TRANS/WP.29/GRRF/2002/16
27 June 2002

World Forum for Harmonization of Vehicle Regulations (WP.29)

PROPOSAL FOR DRAFT AMENDMENT TO REGULATION No. 54

(Pneumatic tyres for commercial vehicles)

"ARRANGEMENT OF TYRE MARKINGS

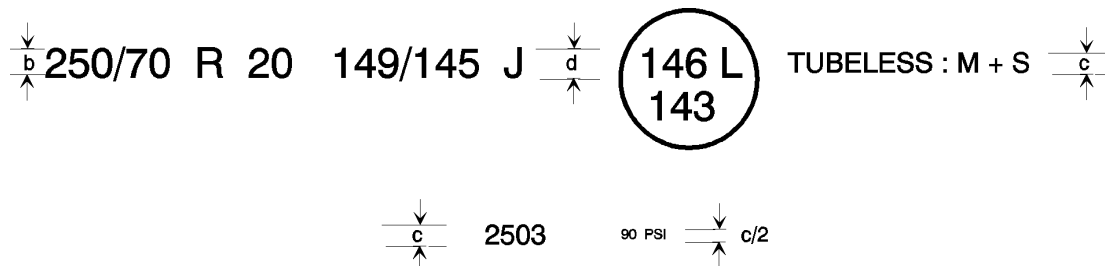
Annex 3, amend to read:

2. In the particular case of tyres having a tyre to rim fitment configuration "A", the marking shall be in the form of the following example:

235-700 R 450A where:

A is the tyre to rim fitment configuration.
